Before the
FEDERAL COMMUNICATIONS COMMISSION
Washington, D.C. 20554

)	
)	
In the Matter of)	
)	
LightSquared Subsidiary, LLC)	IB Docket No. 11-109,
)	SAT-MOD 20101118-00239
Application for Modification of Its Authority)	
for an Ancillary Terrestrial Component)	
)	
)

GPS Interference Report of
Clearwire Corporation

LightSquared “Live Sky” Test Results

LightSquared, Impact of 2° Vertical Downtilt

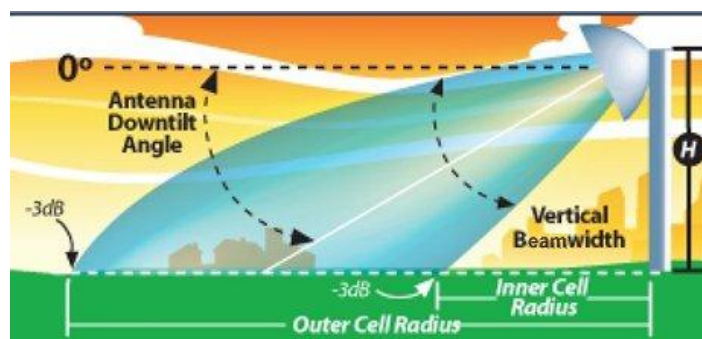
6. **The test did not use realistic antenna downtilt for a LTE system; the 2 degree downtilt LightSquared used for testing means that the most severe interference zones (in the main lobe, closer to the tower) are understated.** Standard LTE deployments vary downtilt according

to morphology,⁸ but will likely use antenna downtilt of 10-12 degrees for dense urban, 6-8 degrees for suburban, and 6 degrees for the most rural scenarios. By using an unrealistic downtilt value of 2 degrees, LightSquared is pointing the main lobe (where the worst interference will be experienced) much further away from the base of the tower, where the signal is attenuated by distance.⁹ Because LightSquared's actual deployment is likely to use downtilt values that put the main lobe closer to the tower base, more severe interference can be expected.

- v. Electrical downtilt values used in testing should reflect real-world values, as opposed to the unrealistic 2 degree downtilt LightSquared chose, which understates the most severe interference closer to the tower.
